**AMENDMENTS TO THE DRAWINGS:**

### **REMARKS**

FIG. 1

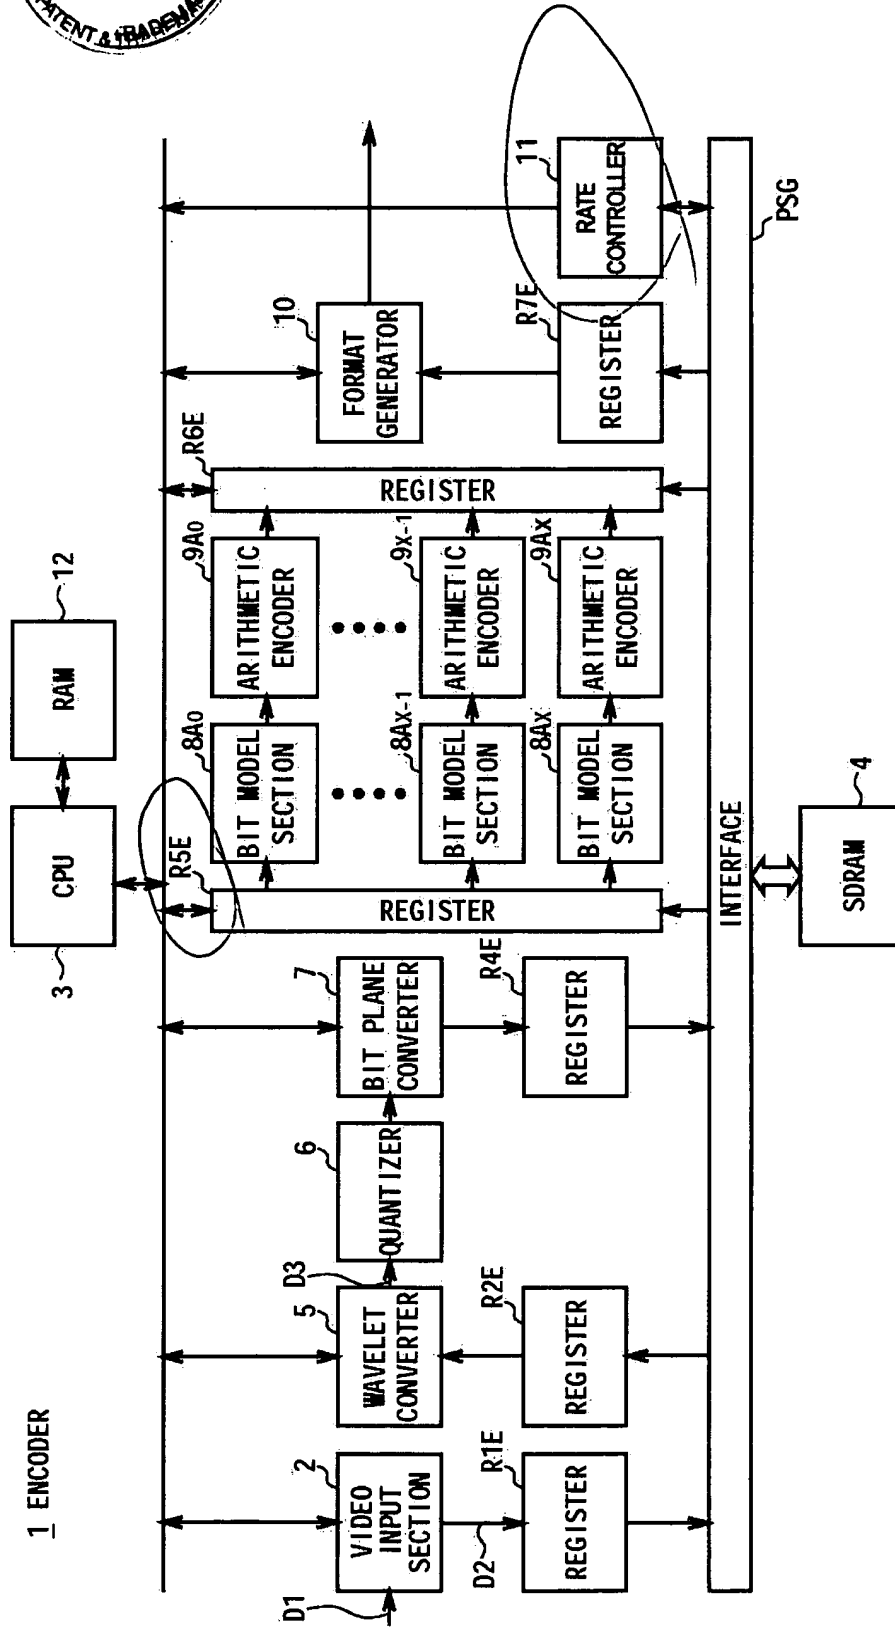
Regarding the objection to the drawings, Applicant has amended Figures 1, 6, 7, and 13. Specifically, Applicant has amended Figure 1 to replace non-English characters in box 11 by --RATE CONTROLLER--, and add reference characters --R5E--; amended Figure 6 to replace "RT0" by --RT1--; amended Figure 7 to replace "BitTmp" by --BitsTmp--; and amended Figure 13 to replace "SP27" by --SP45--, and match reference characters "SP53" and "SP54" with the written description. Applicant submits herewith four (4) sheets of replacement drawings, labeled "Replacement Sheet 1/4," "Replacement Sheet 2/4," "Replacement Sheet 3/4," and "Replacement Sheet 4/4," and four (4) sheets of annotated replacement drawings, marking changes in red. Accordingly, Applicant respectfully requests withdrawal of the objection to the drawings.
